UNITED STATES PATENT AND TRADEMARK OFFICE

APPLICATION NO.	FILING DATE	FIRST NAMED INVENTOR	ATTORNEY DOCKET NO.	CONFIRMATION NO.
10/521,692	05/13/2005	John G Mancino	1872	2171
24264 7590 12/29/2006 MARTIN & HENSON, P.C. 9250 W 5TH AVENUE SUITE 200 LAKEWOOD, CO 80226			EXAMINER DUCKWORTH, BRADLEY	
			ART UNIT 3632	PAPER NUMBER
SHORTENED STATUTORY PERIOD OF RESPONSE			MAIL DATE	
3 MONTHS			12/29/2006	
			DELIVERY MODE PAPER

Office Action Summary	Application No. 10/521,692	Applicant(s) MANCINO ET AL.	
	Examiner Bradley H. Duckworth	Art Unit 3632

DETAILED ACTION

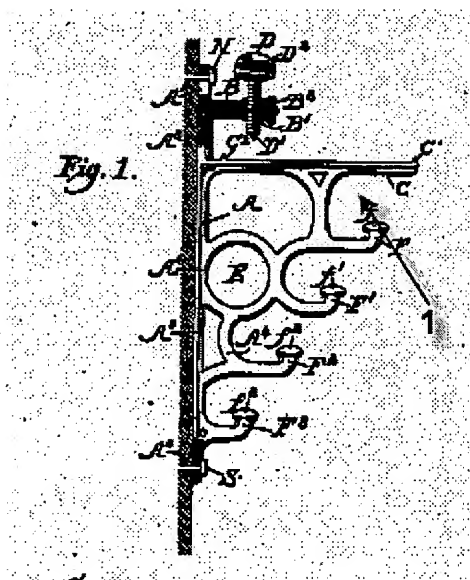
Claims 1,2,4-7, 14-18, 20-25, 29, and 31 are rejected under 35 U.S.C. 102(b) as being anticipated by Heysinger(US000564519). Referring to annotated figure 1 below,

Heysinger teaches a bracket with a base(A) that has a J-shaped mounting portion(B+D) used to mount a shelf, with an elongate beam portion(C) with a planar web portion(E) with a plurality of holes with a slot(1) formed on a forward edge, with a flange(C) on the beam section with a width greater then the web thickness but less then the web height, with a hook structure(F2) extending forward of said base and web, where the hook structure is an elongate arm spaced from said beam portion with a arcuate free end that curves toward said beam portion, with a pad(f2) on the free end forming a rearward extending lip.

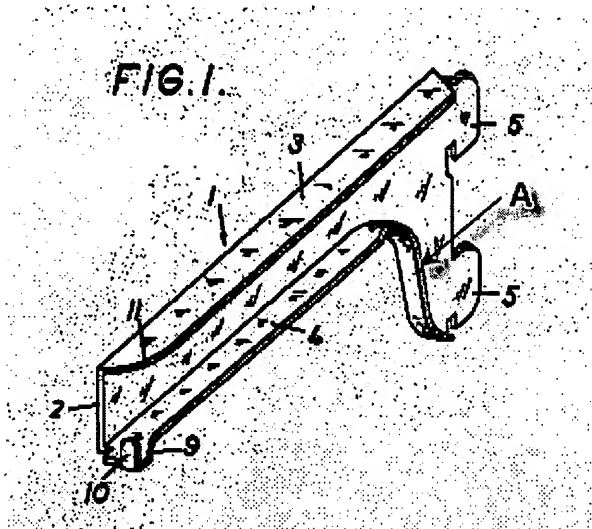
Claims 1,2,3,9,and 10-13 are rejected under 35 U.S.C. 102(b) as being anticipated by Bjerke(US003185426). Referring to annotated figure 1 below, Bjerke teaches a bracket with a base with a j-shaped mounting portion(Upper 5) and a latch structure(lower 5), with an elongate beam member with a web portion(2) with a rearward reinforcement rib(A) with a first flange(3) and a second flange on the lower edge(4) of the web where the second flange width is less then that of the first flange(see

fig 2) but is still greater than the web thickness, where the first flange length is greater than that of the second flange, where the second flange has opposite edges that converge to hook structure (10) that extends forward of said base.

FIG. 3

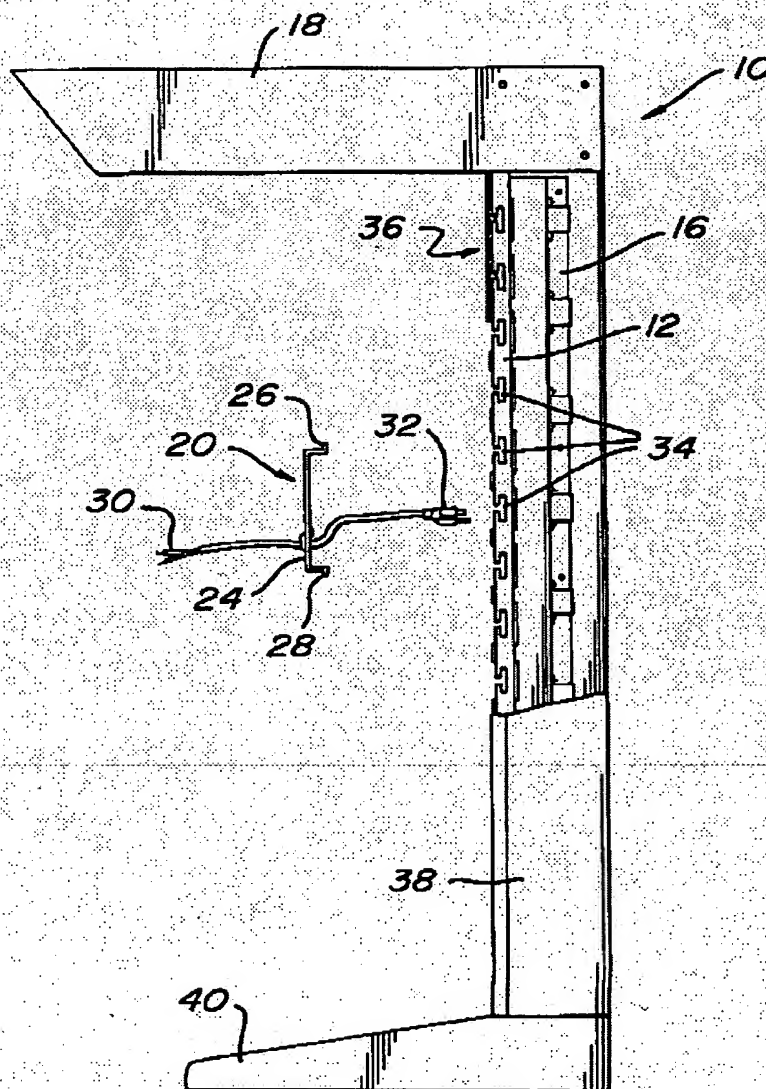
Claims 32,38,39 and 40 are rejected under 35 U.S.C. 103(a) as being unpatentable over Portner, in view of Bjerke in view of Heysinger as applied to claim 21 above. Referring to Figure 3, Portner teaches a lighting fixture display comprising a support member(32) in a vertical orientation relative to and attached to a support structure(10), as well as brackets to hold lighting devices and their wires. However Portner does not disclose the use of brackets comprising a base, with an elongate beam portion with a flat upper surface, a web portion, and an elongate support arm spaced apart from said beam, such as the bracket created with the modified bracket of Bjerke of claim 21 as detailed above. It would have been obvious to replace the brackets of Portner with a pair of brackets of Bjerke, because the modified brackets of Bjerke would allow for the support of a large range of items, including a shelf and any item that could be mounted on a shelf, such as larger light devices. In regards to claim 38, applicant admits cable connectors are known in the art, and it would have been

obvious to one of ordinary skill in the art at the time of invention to use a cable connector with the plurality of holes on the support member of Portner, because the holes already provide a track for cables, and the inclusion of a connector between the wire and the slot-hole would act to secure the cable in the slot.
